Bowdens Proposal: Hydrogeology

IPC 15 Feb 2023

Lue Action Group

Review of Bowden's Response to Groundwater Questions: Bowdens' March 2022 Amendment Report

Figure 4: Site Geology, adapted from (R.W. Corkery & Co., March 2022c, pp. 2-10)

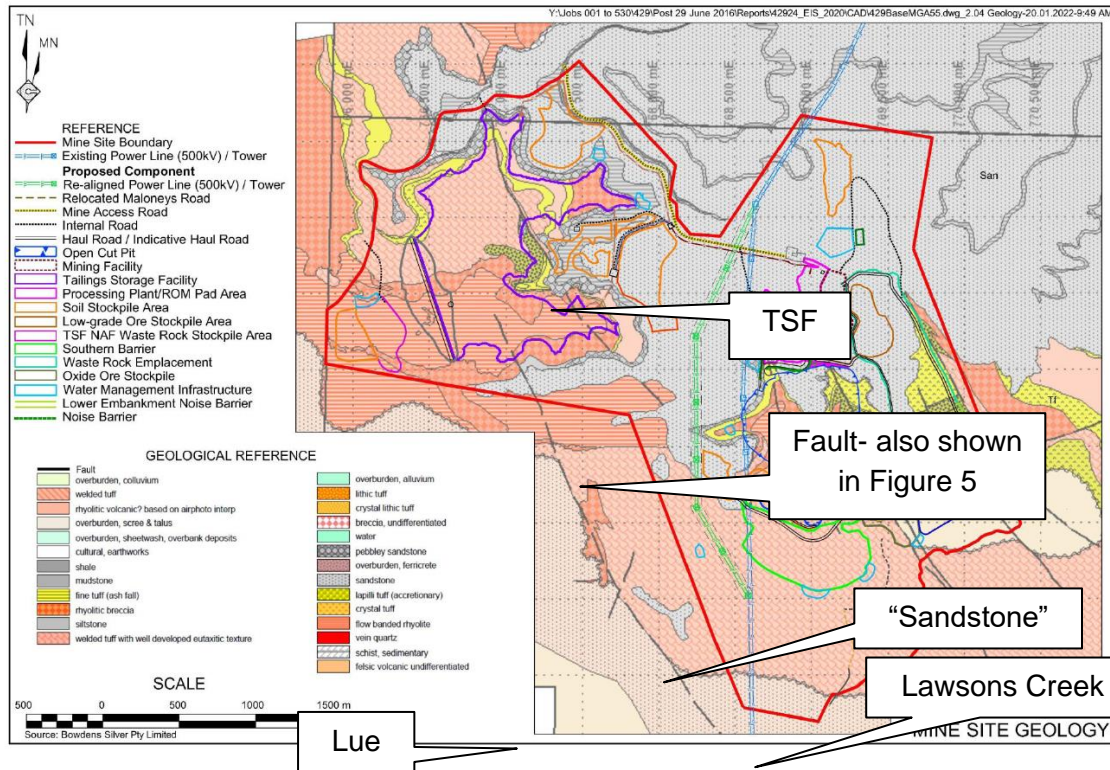
The lack of bores to inform (hydro)geological interpretation outside the site reduces confidence in the model outputs. The following figures show recent amendments to the groundwater model and compares these to the data that is presently available to inform these interpretations.

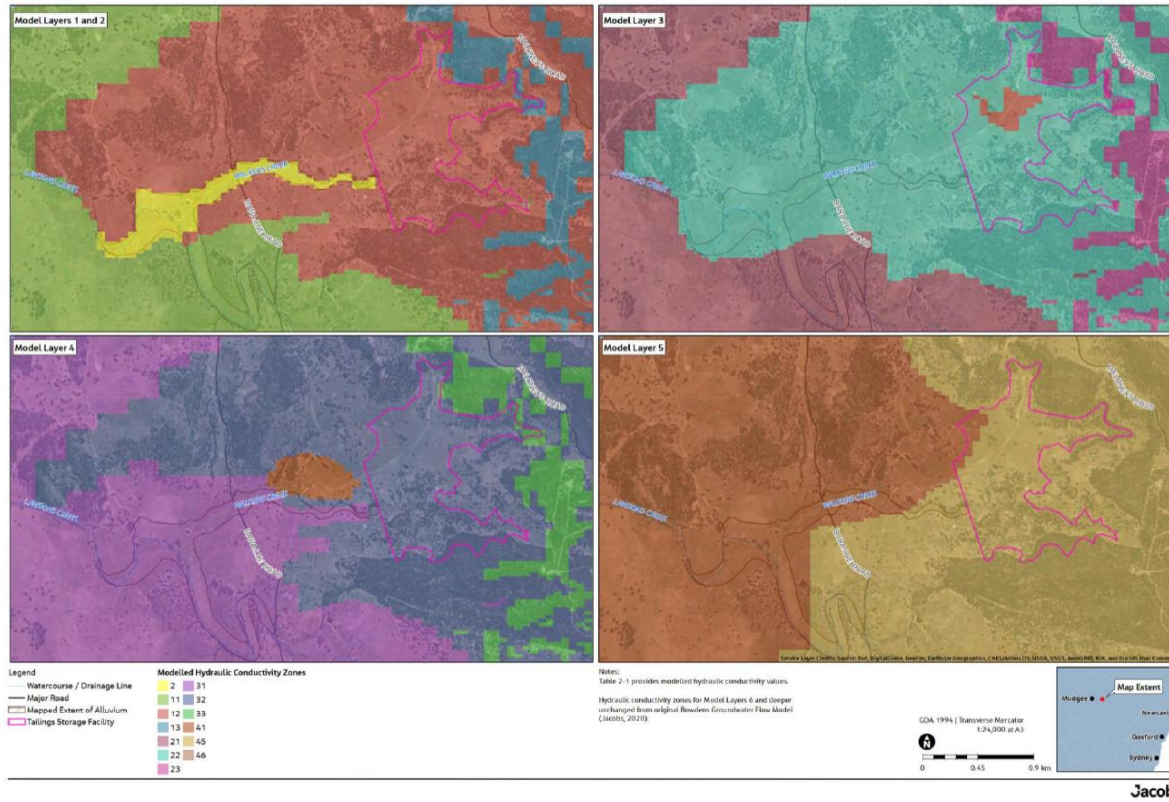
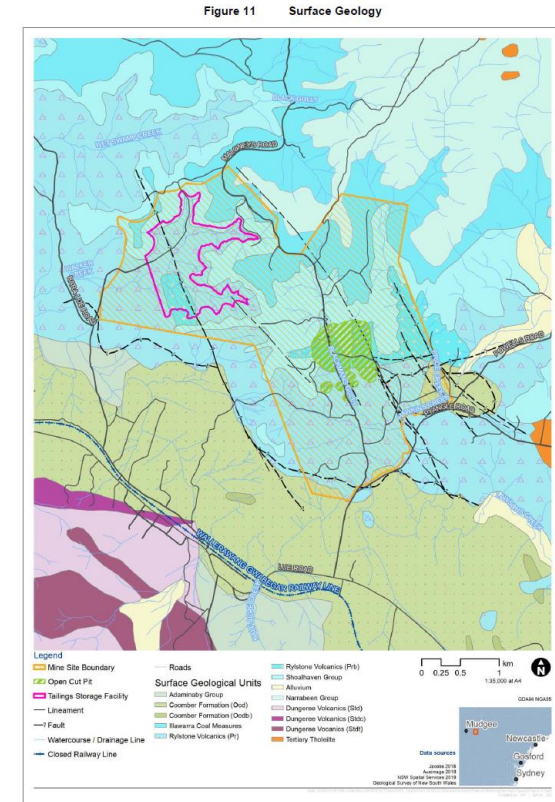
Figure 5: Changes in hydraulic conductivity (R. W. Corkery & Co., 2022d, pp. 5-400) and surface geology (R. W. Corkery & Co., 2022d, pp. 5-56). Codes for modelled hydraulic units are shown on page 5-398. The modelled hydraulic conductivity of the alluvium is truncated by Zone 31 (higher hydraulic conductivity based on Bowdens' regional groundwater flow model). Any aquifer pumping test data undertaken has not been provided to support the interpreted hydraulic conductivity/zone boundaries.

Information regarding the local groundwater response is uncertain with or without external supplies. The impact of seasonal changes to groundwater level (and associated groundwater flow changes) is not presented and the uncertainty in the fractured rock hydrogeology is not shown using a full range of possible outcomes. The 2014 extended aquifer pumping test on BGW10 and BGW108 highlighted the influence of no-flow boundaries/lineaments within 100 m. Groundwater levels did not fully recover after 10 days. Pumping tests over 30 days and dewatering test pits would better reflect the sustainable yield of bores and better inform the hydraulic conductivity and storage of the dual porosity model and inform the new 'horizontal flow barriers / HFBs' used in the model (Figure 5) (R. W. Corkery & Co., 2022d, pp. 5-408).

Figure 6: Modelled thickness of combined Layers 1 and 2 (R. W. Corkery & Co., 2022d, pp. 5-397)

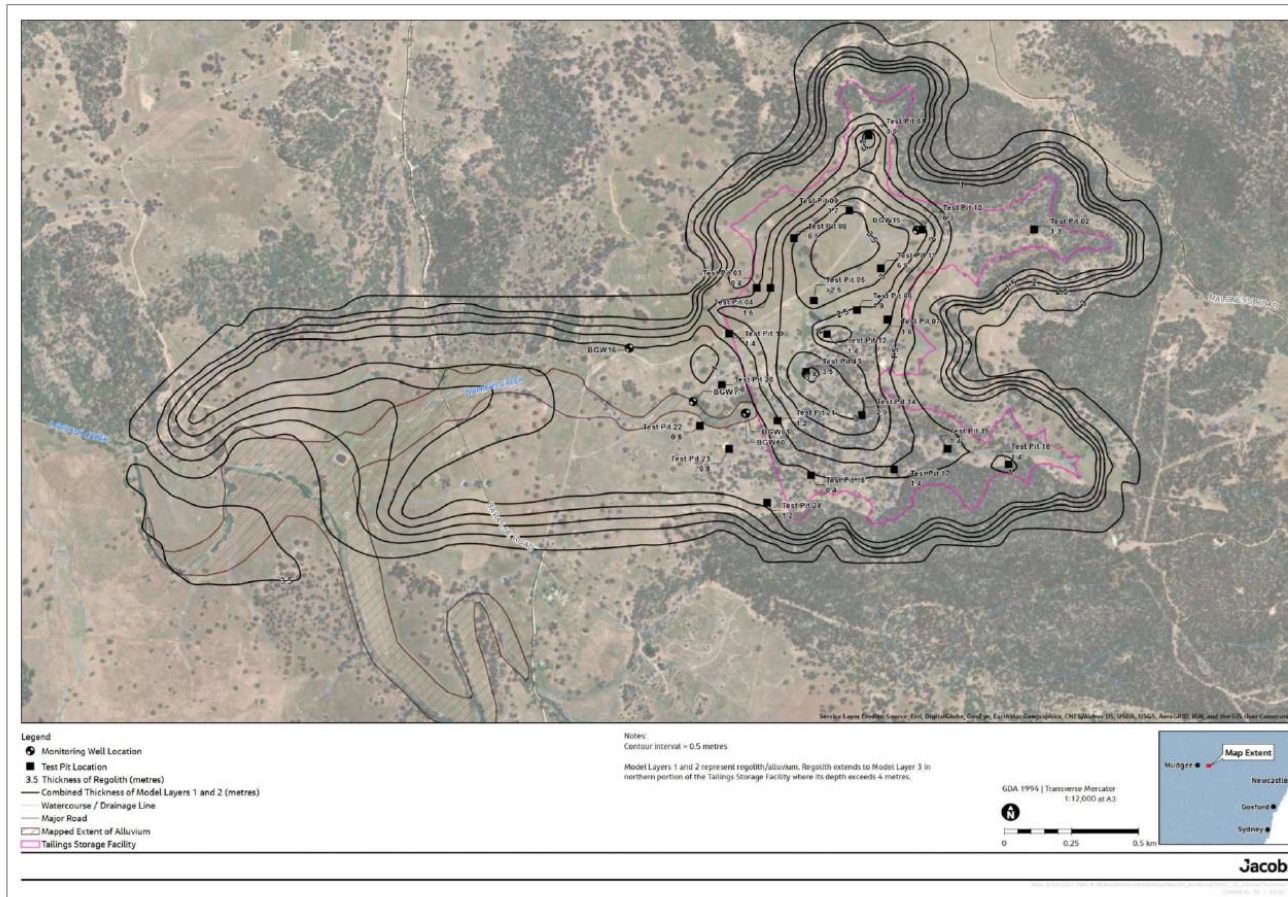
Figure 6 shows the modelled thickness of the upper two layers, but does not provide any guidance regarding the assumptions (e.g. geological logs) supporting this hydrogeological interpretation. Figure 7 and Figure 8 show the impact of the altered hydrogeology on modelled groundwater drawdown impacts; acid leachate is modelled to report to the pit in the outputs provided, not the creeks.

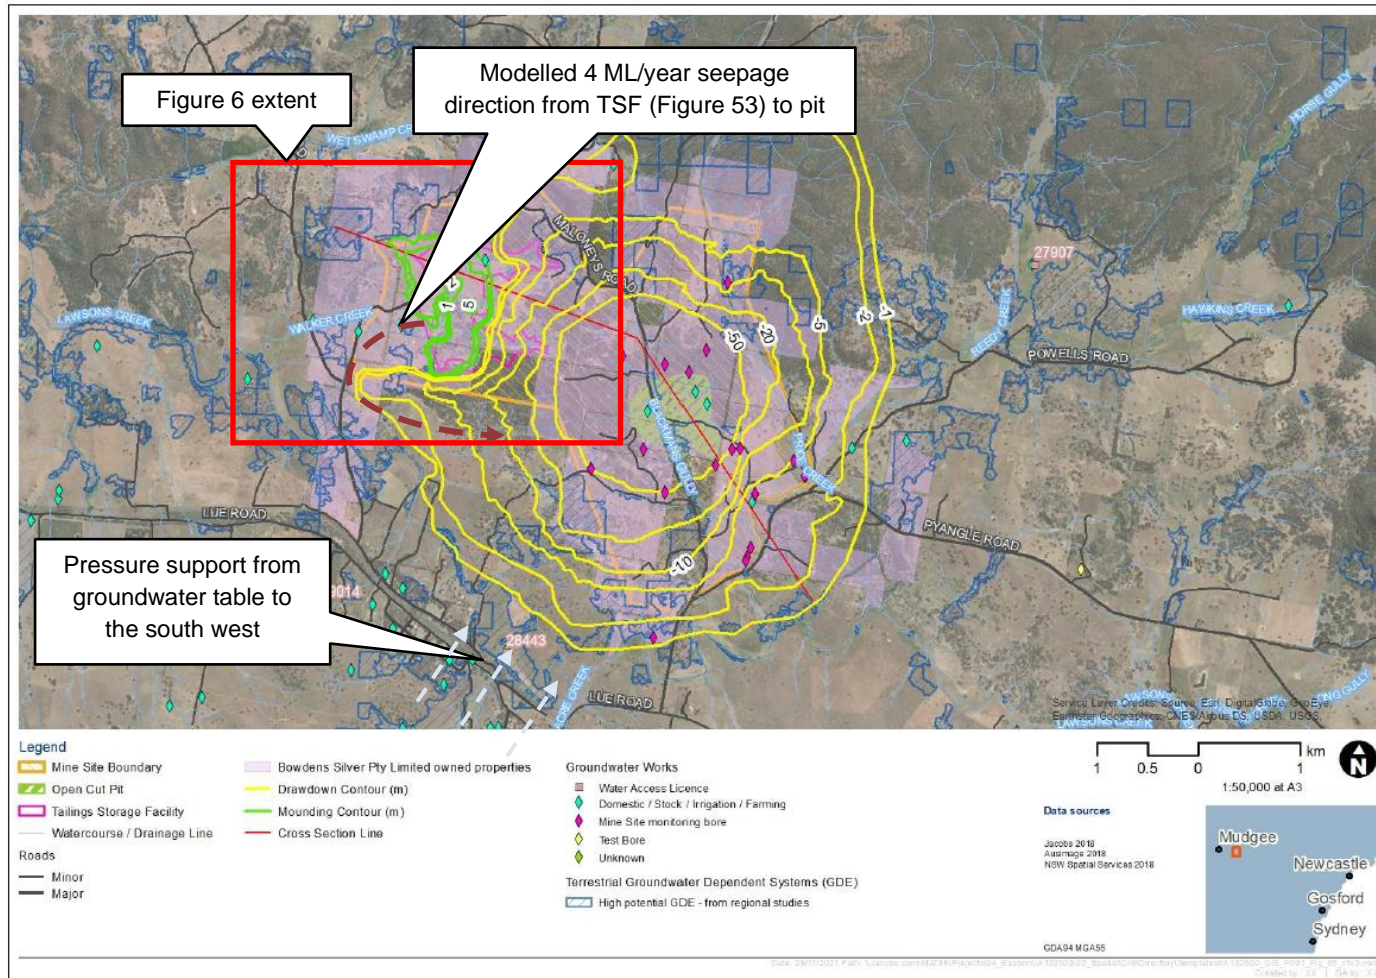
Figure 7: 2022 Year 9 modelled drawdown, influenced by zone/layer distribution, modified from (R. W. Corkery & Co., 2022d, pp. 5-127), showing hydraulic communication between the TSF and the pit, indicating leakage / pressure support from the TSF reporting to the pit as well as groundwater pressure support from the south west. NB. Figure 53 appears to mislabel Option 1 and Option 2 with BGM.
